Ref: B19041  
16 August 2023

**Subject:** Newcombe Road Sand Quarry – Section 92 Response  
**Issued via:** Christian@kineticenv.co.nz

Figure 1: Redistribution of Trucks

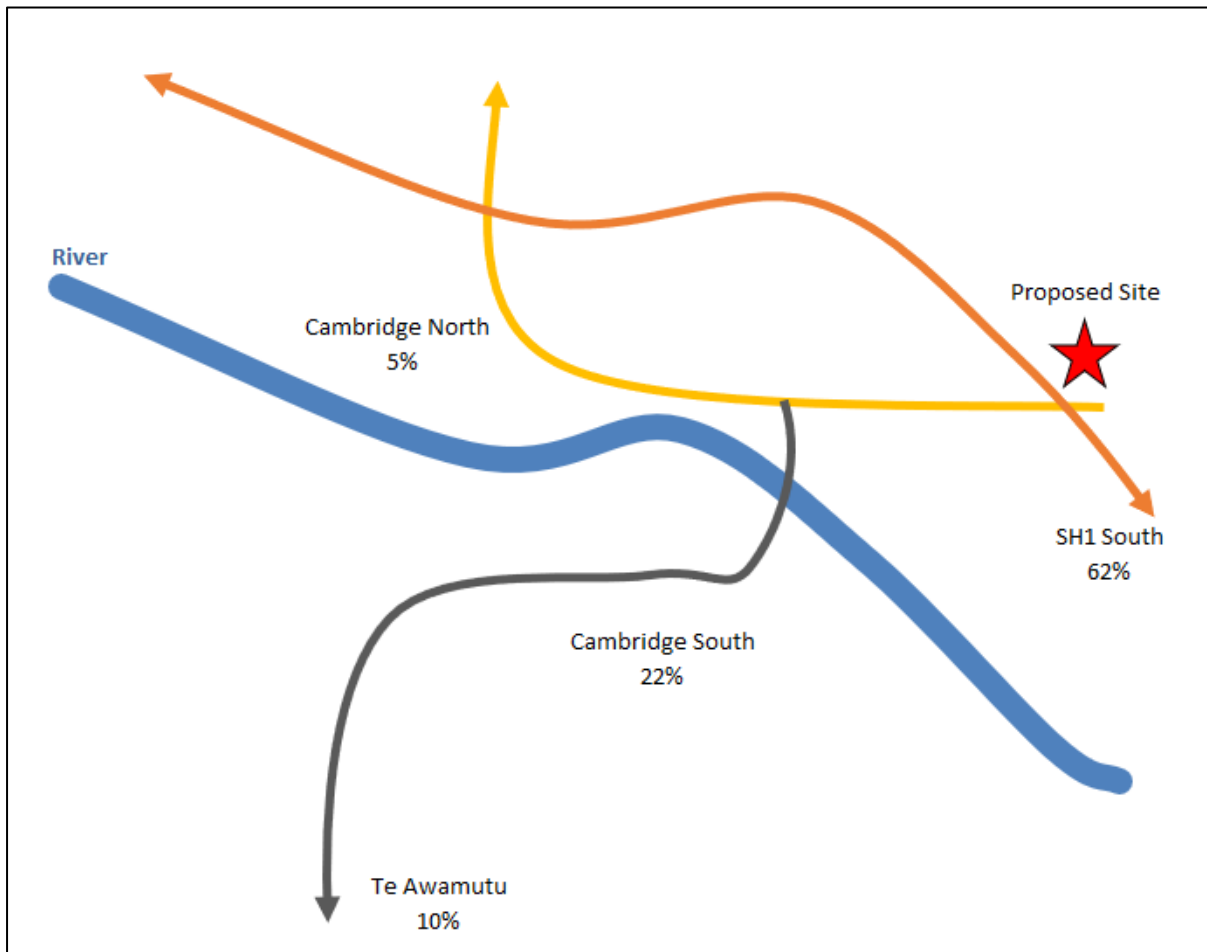
*2.b)A) – Please explain the basis for deriving the distributional split shown in Figure 5.*

*2.b)B) – Please provide sensitivity assessments for the assumed distributional split to stress test the urban network constraints within Cambridge (capacity, safety, amenity) and then provide an assessment of the likelihood of the various scenarios (and associated effects) occurring.*

However, since the ITA was prepared, new turnaround facilities on SH1 have been constructed that create an alternative feasible option for northbound trucks that avoid the town centre. While this route increases travel distance by approximately 7km, the road is generally flat and straight with no driveways or other intersection to disrupt traffic flow. In contrast the route through the town centre is slow with frequent intersections and there is also a notable gradient up Queen Street which would have a noticeable effect on trucks. The route through the town centre can also be congested at peak times. Therefore, the route via SH1 is considered to be more attractive for trips heading north from the site. The only exception may be trucks delivering product to sites close to the town centre such as at the southern end of the C2 growth cell. To allow for some trucks to use this route, 5% of trucks have still been conservatively estimated as travelling through the town centre with all other trips north using the turnaround facility on SH1. The revised distribution is shown in Figure 1 below. The HVIF calculations have been updated to reflect the change in distribution and also incorporate other feedback.

Based on the revised distribution, it is estimated that up to eight truck movements an hour would pass through the town centre. An increase of this magnitude is unlikely to be noticed by other road users through the town.
